**TOWN OF YARMOUTH**  
200 Main Street, Yarmouth, Maine 04096  
[www.yarmouth.me.us](http://www.yarmouth.me.us)

**Planning Board Report**  
**Travis Roy Arena, 497 Route One**  
**Concept Plans for Building & Lot Plan & Major Site Plan**  
**North Yarmouth Academy, Applicant**  
**Map 32 Lot 125; SD-1 NYA Campus Special District**  
**Prepared by Erin Zwirko, Director of Planning and Development**  
**Report Date: January 6, 2022; Planning Board Date: January 12, 2022**

Site Plan with Proposed Expansion identified in Bold

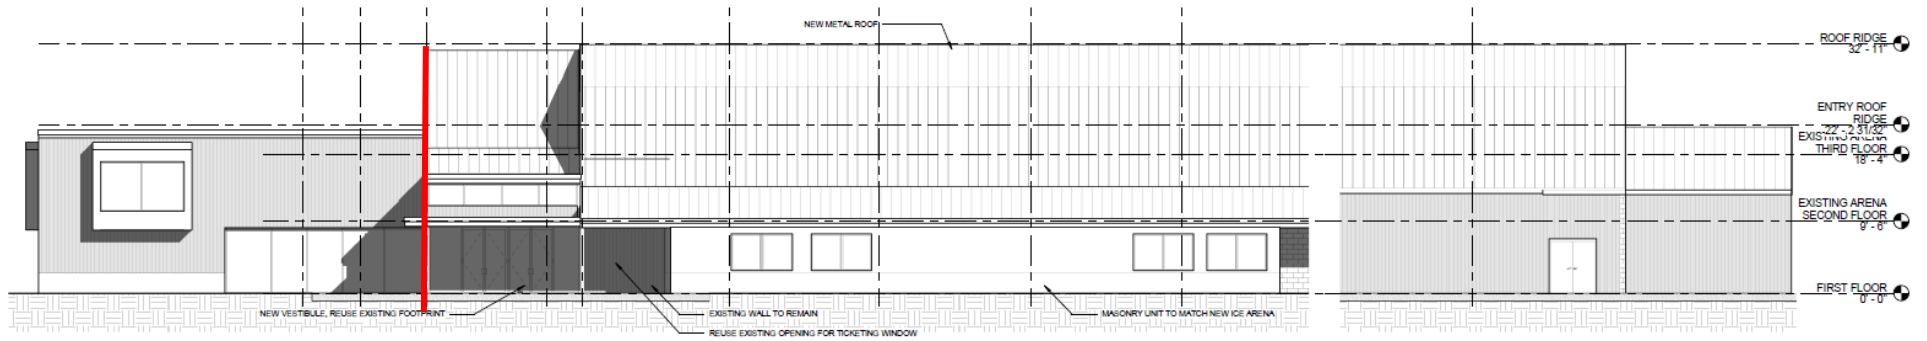
The existing Arena is the principal building and there are a number of outbuildings associated with the Arena. A shed is proposed to be relocated, but it appears that it would be relocated to within 20 feet from the external property boundary. The location of this shed may need to be reevaluated.

The existing parking lot will be restriped. The applicant may consider adding additional vegetation to the parking lot edges to provide shade and be protected from vehicular damage.

The site plans also note that the striping in the lot is nonexistent. The parking lot will be grinded to remove any existing striping as necessary, and the lot be restriped consistent with the site plan. With restriping planned, the applicant should consider adding pedestrian walkways through the parking lot to indicate safe pathways to the main entrance of the Arena and other points on the NYA Campus. Currently only two crosswalks are shown that connect the Arena to the pathways to Route One, and there are no crosswalks shown from the southern end of the parking lot or from the satellite parking at Clayton's.

Additionally, elements required by the CBDC need to be added to the site plan. The parking lot should be assessed to determine whether additional trees can be provided within or around the parking lot to provide shade and meet the standards of the CBDC. Additionally, the CBDC requires one electric vehicle charger for every 30 parking spaces, and the applicant should assess where chargers may be installed. Finally, additional information should be provided regarding bicycle racks. The CBDC requires one bicycle rack, which can park two bicycles, for every 20 parking spaces. Additional information may need to be provided on chargers and bicycle racks across the school campus to document compliance. Town staff recommend installing the requisite number of bicycle racks due to the proximity to the Beth Condon Pathway and would not support a waiver.

Proposed West Elevation; New Construction is Left of the Red Line

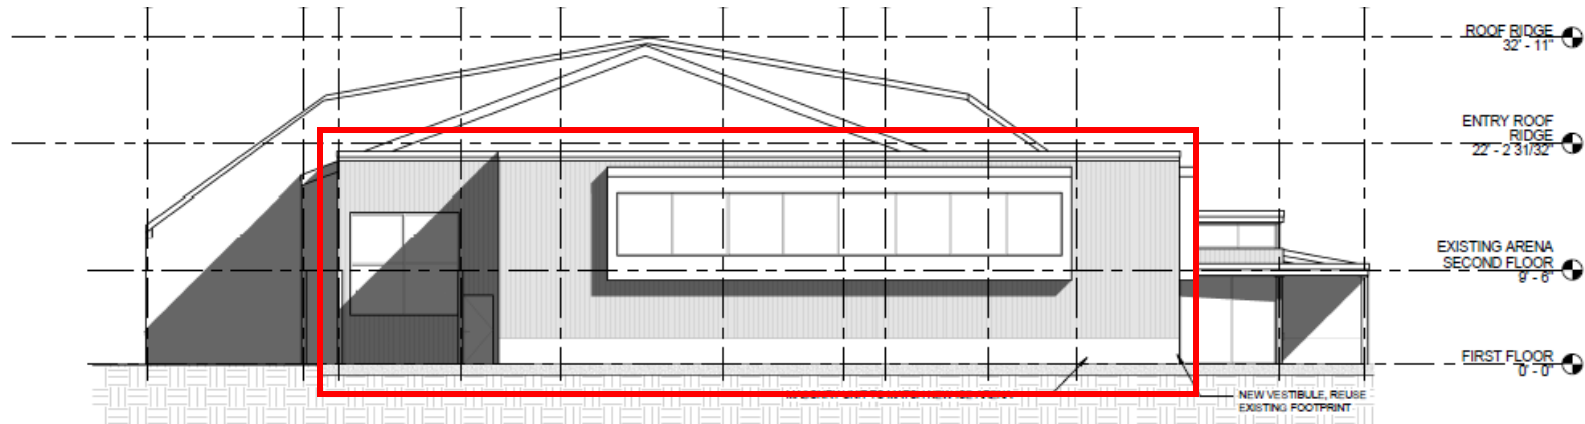
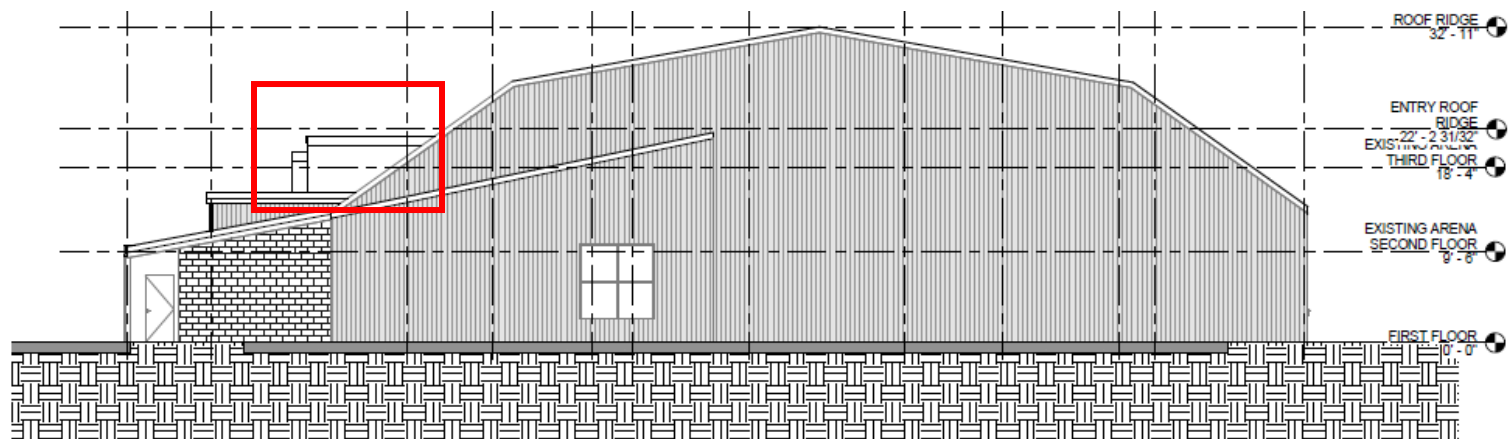
The conceptual Arena design is institutional in nature, which may be appropriate for the expansion of a pre-existing building. The façade materials include the primary corrugated metal panel, a secondary metal panel that will be of a different texture and color, and a masonry unit either consisting of brick or ground face block to match the existing institutional qualities of the campus. The building includes a new main entrance, and the proposed addition is a two-story expansion as shown in the rendering below. Additional details regarding the façade materials and compliance with the CBDC architectural standards will be necessary for the Town staff to fully assess the proposal

The applicant has identified the need for one waiver from the requirement that single glass panes be no larger than 20 square feet. In reviewing the above rendering, it is clear that the windows on the addition may exceed this requirement. The applicant indicates that it is done to match the scale and proportion of the new design as well as the existing building and its proportions, including existing aluminum storefront units which also exceed the 20 square foot maximum. The applicant indicates that this condition is similar to other campus buildings. Currently, the Town staff do not have any concerns with this waiver request and anticipate that a formal request would be made with a future submittal. The Planning Board may want to provide feedback on the identified waiver.

Composition	The proposed façade improvements that correspond with the proposed addition are institutional in nature, which may be appropriate for the expansion of a pre-existing building. The expansion of the principal entry will create a strong focus on the primary façade. However, the proposal may need to improve the fenestration, establish a good base to the building, and create a better coordinated composition between the existing building and the proposed addition.
Walls	Although it appears that the proposal is in compliance with this architectural standard group, additional details regarding the façade materials may be warranted, and in particular for the metal cladding.
Attachments & Elements	Bay windows, such as the punched out windows proposed for the second floor, are required to have certain design features to complement the building. It is not clear that the proposed bay windows meet these standards.

Roofs	A flat roof is allowed; however, the relationship between the proposed flat roof, the existing Arena roof, and the proposed roof over the new primary entrance work together. Additional details are necessary. The applicant may want to consider the use of a white membrane/high albedo roofing materials or a green roof, or even solar panels.
Openings Windows, & Doors	The style of windows proposed departs from recent examples of a traditional aesthetic, and in fact, the box style windows require certain elements as discussed above. The applicant has identified the need for a waiver that no single pane of glass be more than 20 square feet.
Shopfront	This architectural standard group is not applicable.
Miscellaneous	It appears that the proposal is in compliance with this architectural standard group; however, details about the location of mechanical and utility equipment may be necessary.
